MODIFICATION TO DRB22-0859 APPROVAL FOR SINGLE FAMILY RESIDENCE

DRB FILE No. DRB25-1105

4,5,6 STAR ISLAND DRIVE

PURPOSE OF MODIFICATION:
SEEKING DRB APPROVAL OF 34 FT MAXIMUM BUILDING HEIGHT AS OF RIGHT UNDER CURRENT MIAMI BEACH RESILIENCY CODE

POST FILING MODIFICATION TO UNIT SIZE

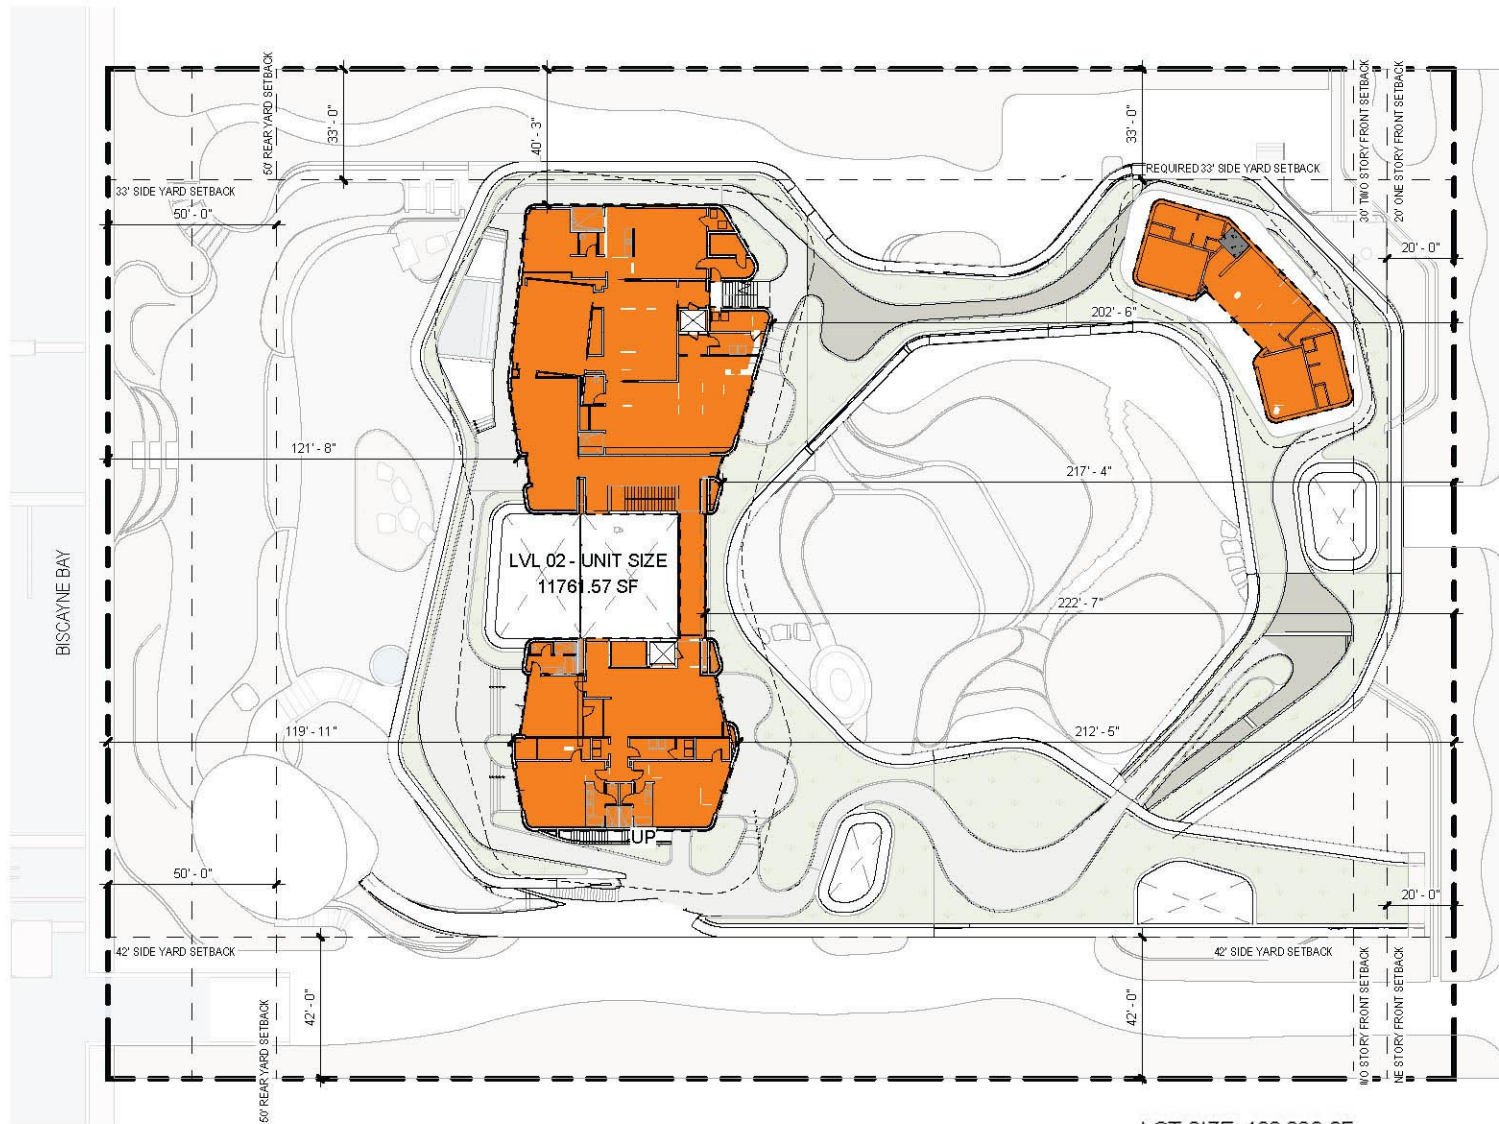
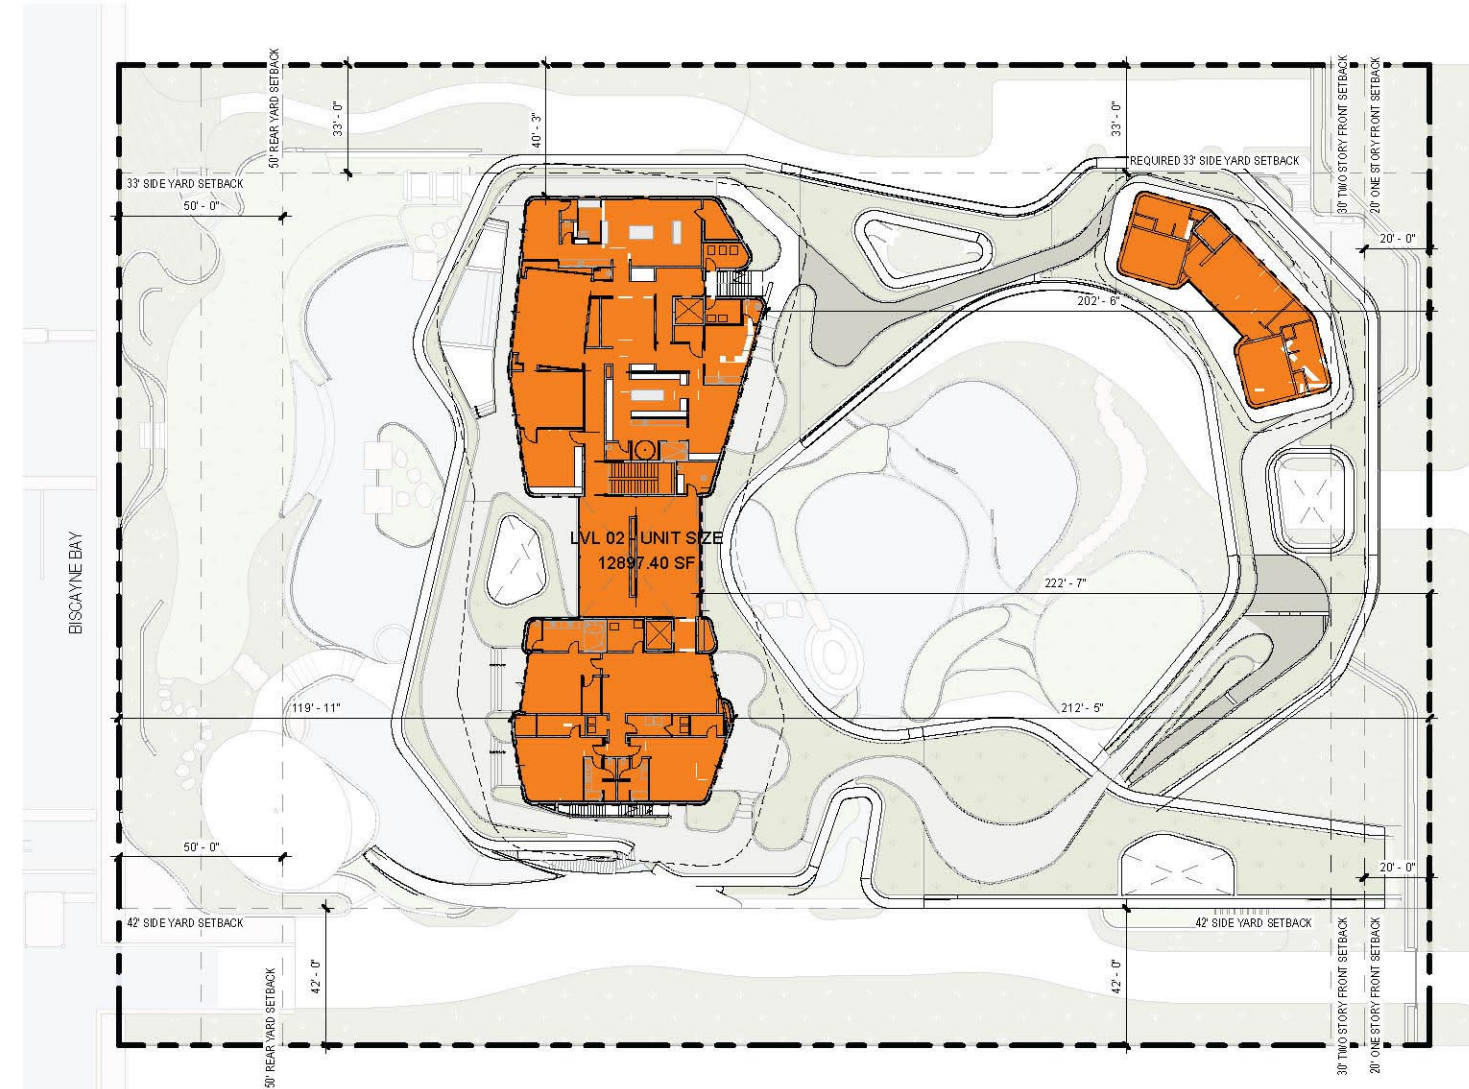
PROPOSED UNIT SIZE:
UNDER STORY: 7,999.36 SF
LVL 01: 19,872.92 SF
LVL 02: 11,761.57 SF
ROOF TERRACE: 166.27 SF

SUBMISSION	SQUARE FOOTAGE
2022	10,126 SF
FINAL 07/13/25	11,761.57 SF
LATEST	12,897.40 SF

PROPOSED UNIT SIZE:
UNDER STORY: 7,999.36 SF
LVL 01: 19,872.92 SF
LVL 02: 12,897.40 SF
ROOF TERRACE: 166.27 SF

SUBTOTAL: 40,936 SF (34%)

NORTH ELEVATION

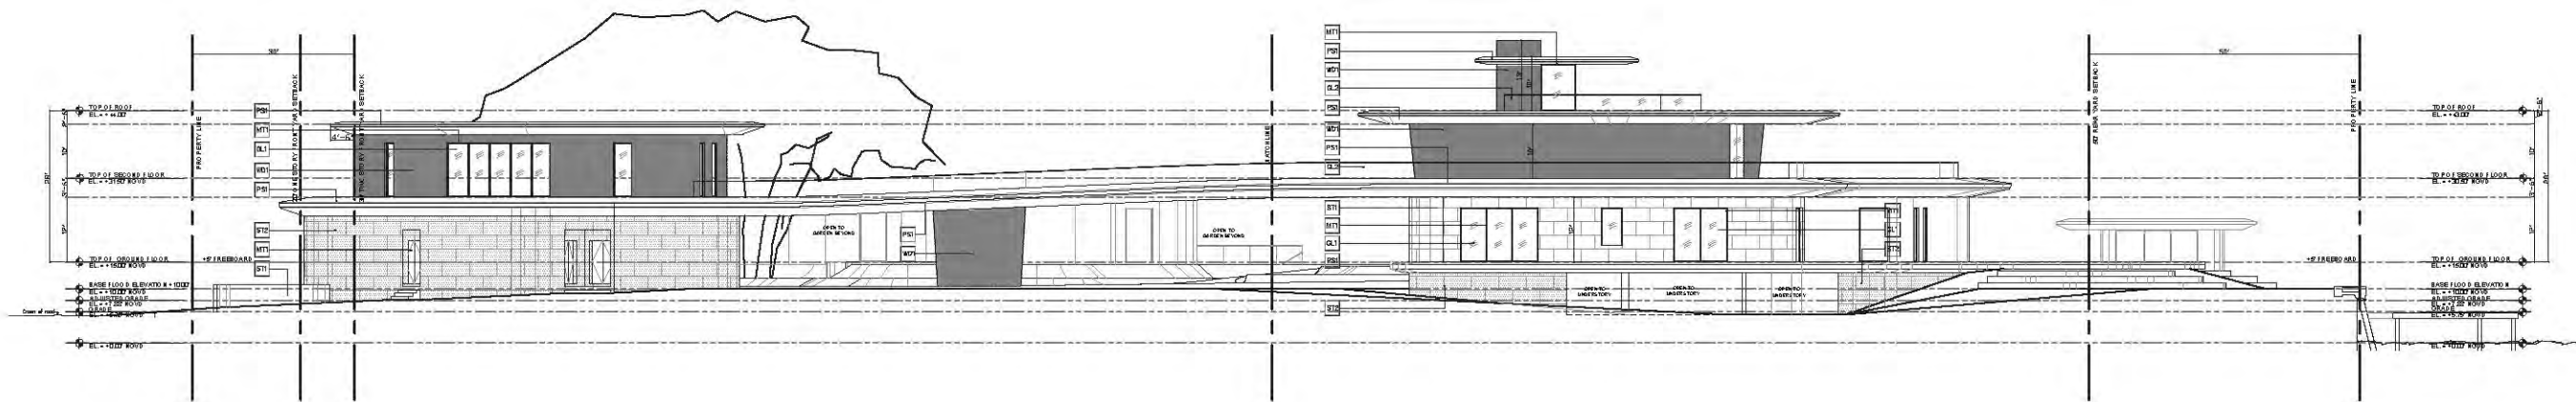
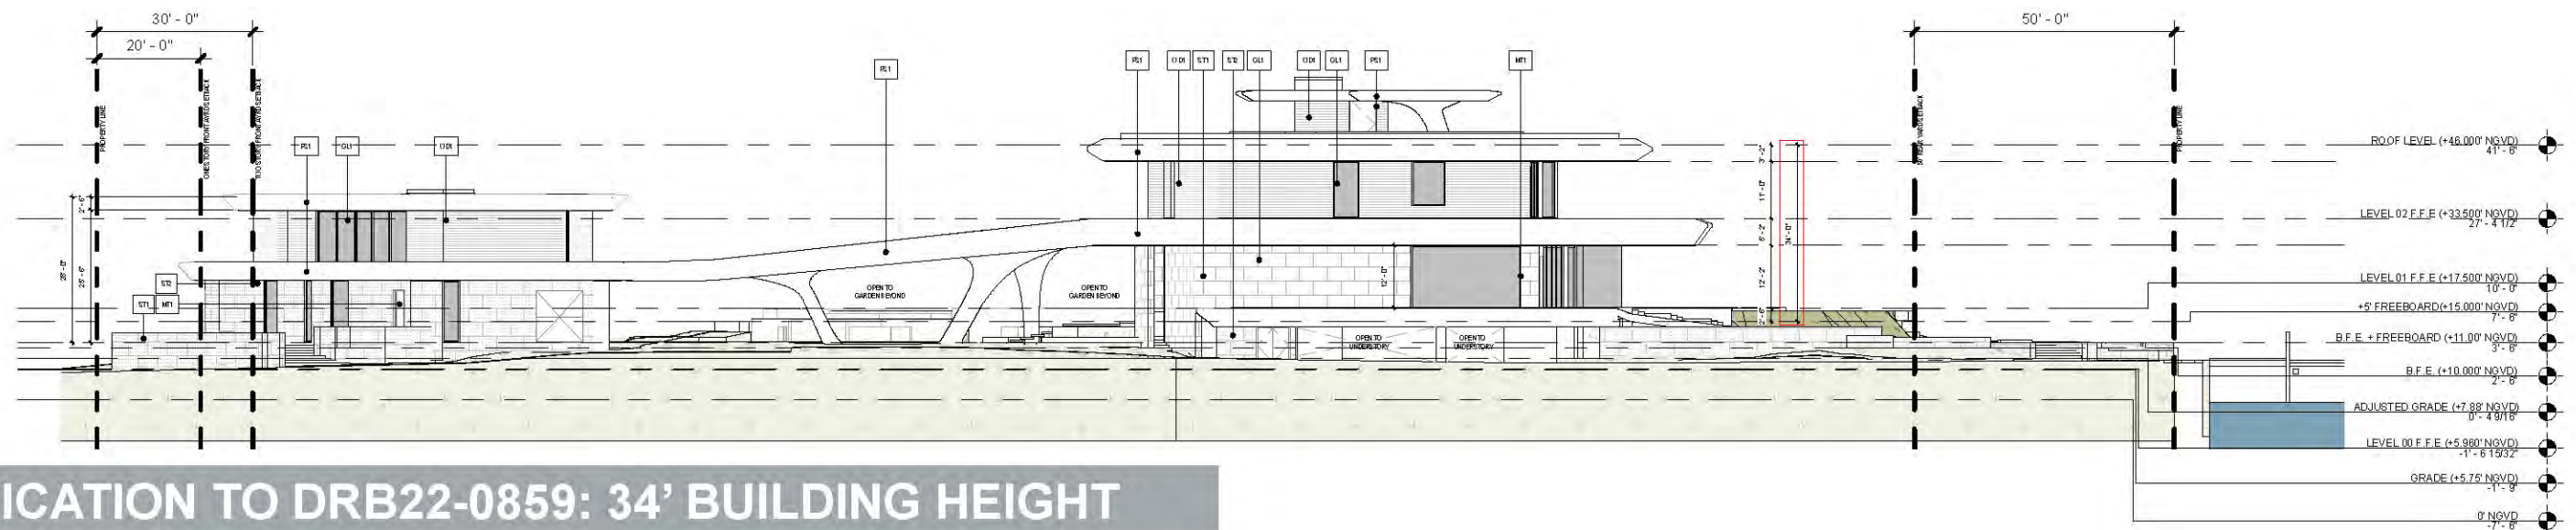
MODIFICATION TO DRB22-0859: 34' BUILDING HEIGHT

EAST ELEVATION

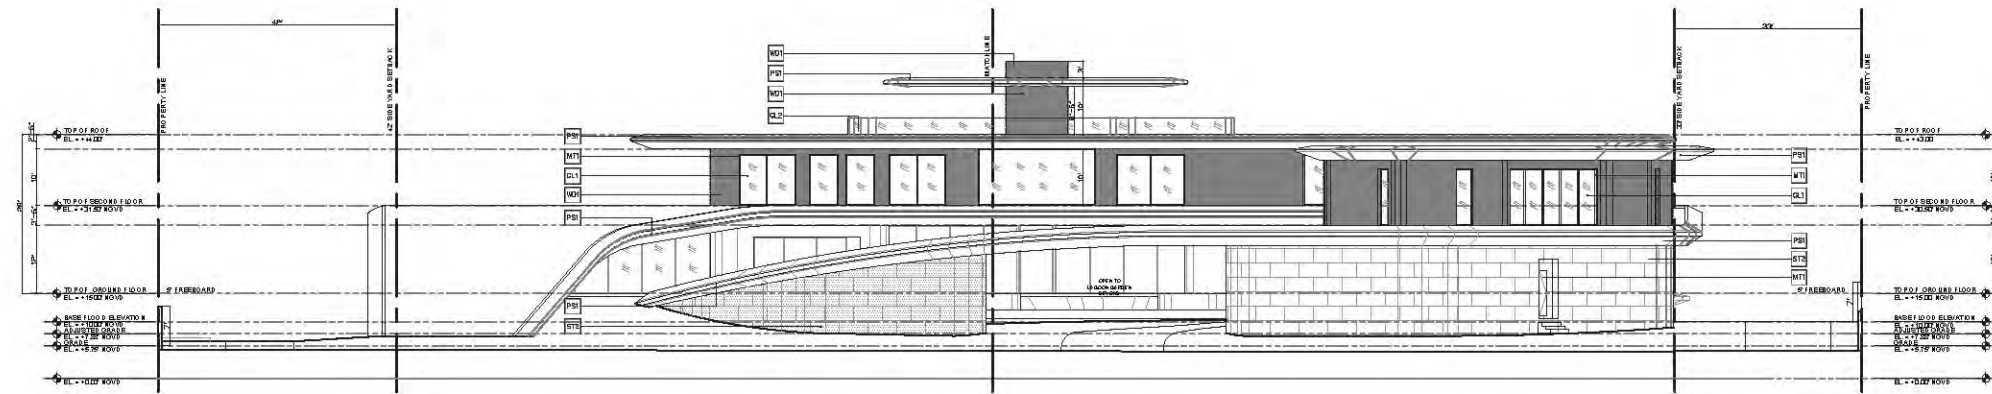
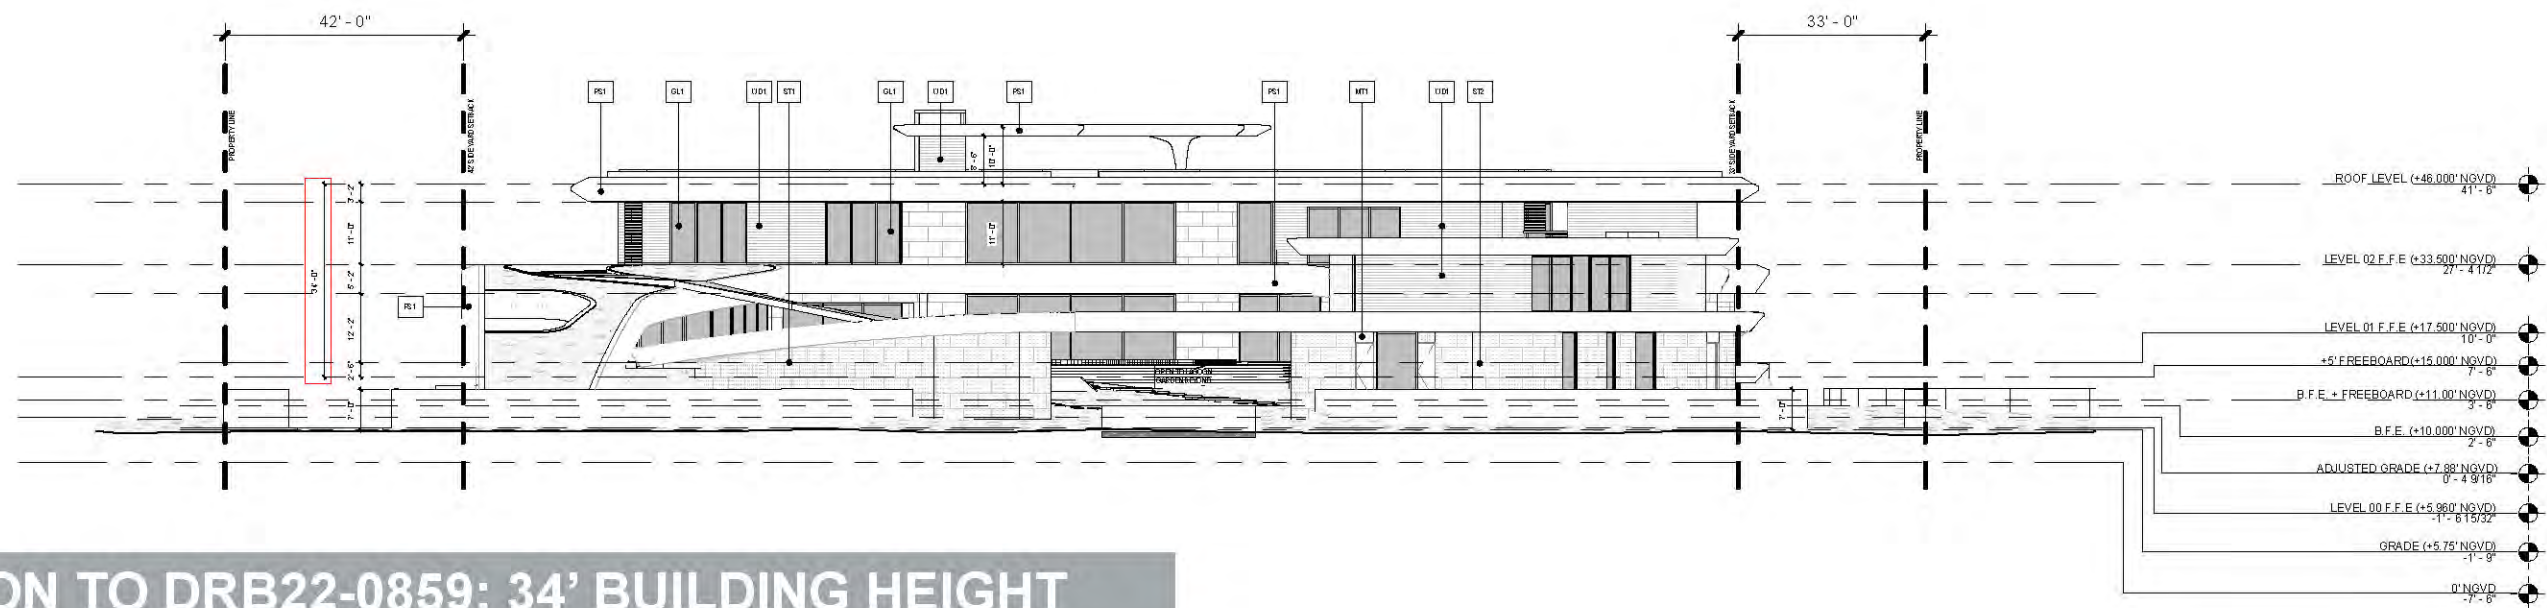
MODIFICATION TO DRB22-0859: 34' BUILDING HEIGHT
